CITY PLANNING COMMISSION

APPLICATION: A. Negative Declaration
B. South Pocket Community Plan Amendment
C. Rezone from R-1A (PUD) to R-1 and R-2B-R (Sec. 2-B-1)
D. Tentative Map (Sub. Ord.)

LOCATION: Southwest corner Land Park Drive; Greenhaven Drive extension

APPLC. NO. P84-425

TYPICAL UNIT PLANS

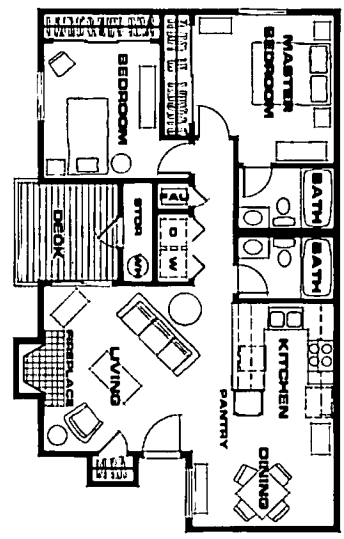
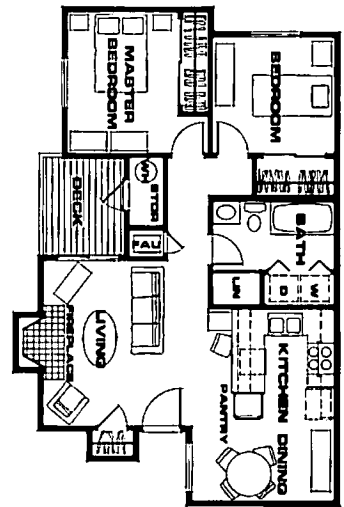
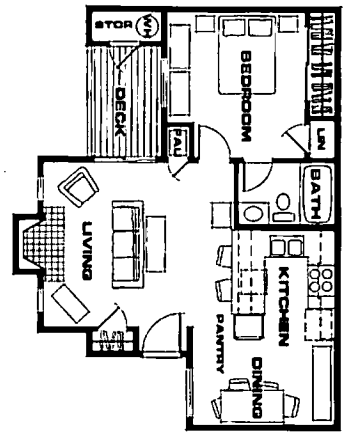
- C. Building Design - Multiple Family: The building elevations indicate that shiplap board siding will be used on the exterior of the structures. The roof lines are varied to provide interest and will be covered with a shake material.

The unit sizes range from 625 square feet to 881 square feet. Each unit will be provided with a fireplace and the two-bedroom units will have a washer and dryer.

SCHEMATIC
SITE
PLAN

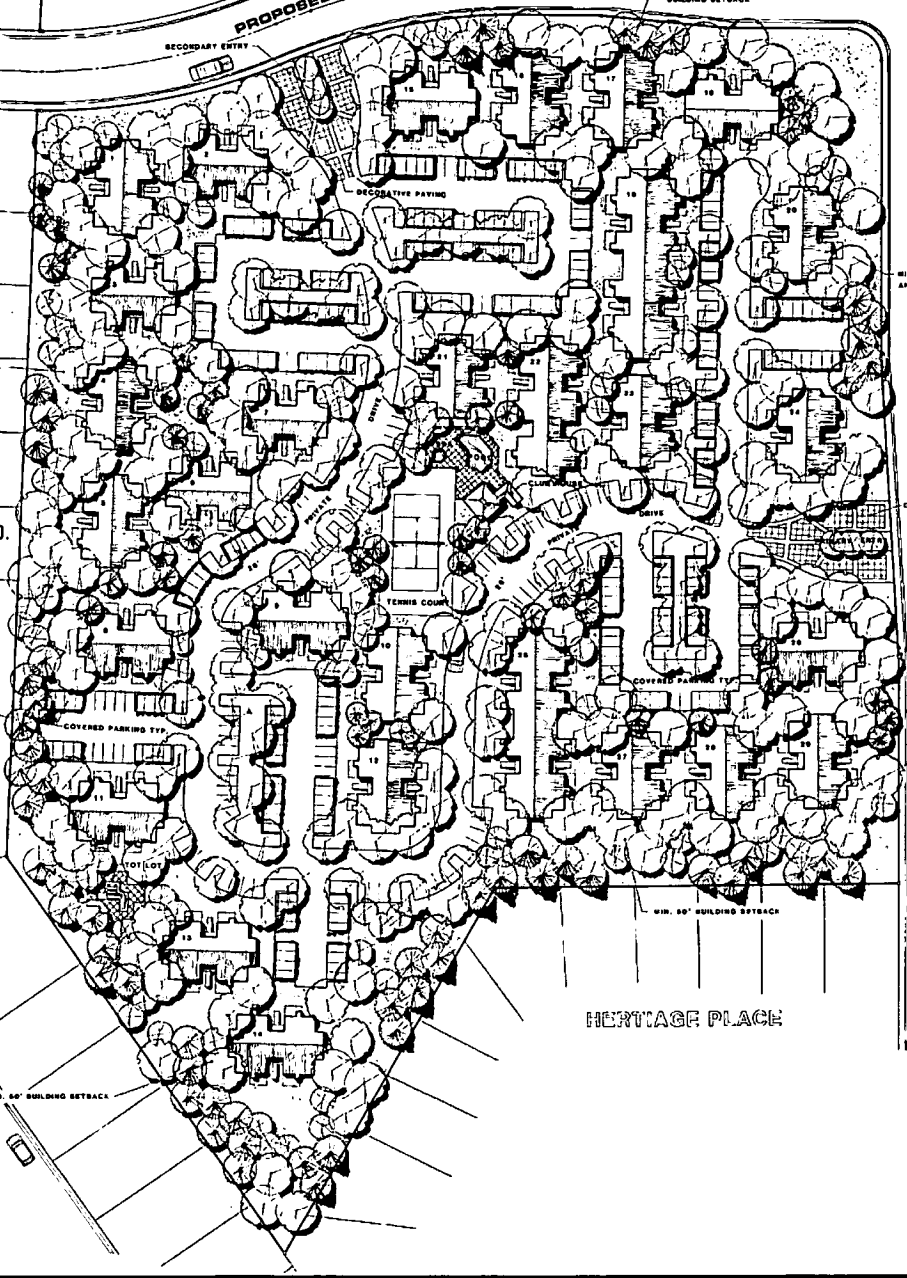
B. Site Design - Multiple Family site: As indicated in the site plan, the applicant has utilized a curved drive through the complex which connects with South Land Park Drive on the north and Greenhaven Drive on the east. The buildings have been arranged in clusters using 26 eight-unit structures, two 16-unit structures and a 12-unit building near the recreation room. The use of different building sizes creates interest and provides variety in the site design.

In an effort to discourage parking along the public street by tenants and their guests, the applicant has used the smaller structures along the street frontages. These smaller buildings provide a more direct access to the on-site parking from the units.

The applicant will also be providing a minimum 25-foot building setback along street frontages with greater setbacks provided for those structures with units fronting on public streets. Staff recommends that all street setback areas be developed with a minimum four-foot berm which should be heavily landscaped with evergreen trees and low shrubs and ground cover. All other setback areas which are adjacent to the single family uses should be heavily landscaped with evergreen trees and ground cover or low shrubs. All landscaping, trash enclosures, bicycle parking and parking lots shall conform to the attached Exhibit A (Residential Design Criteria).
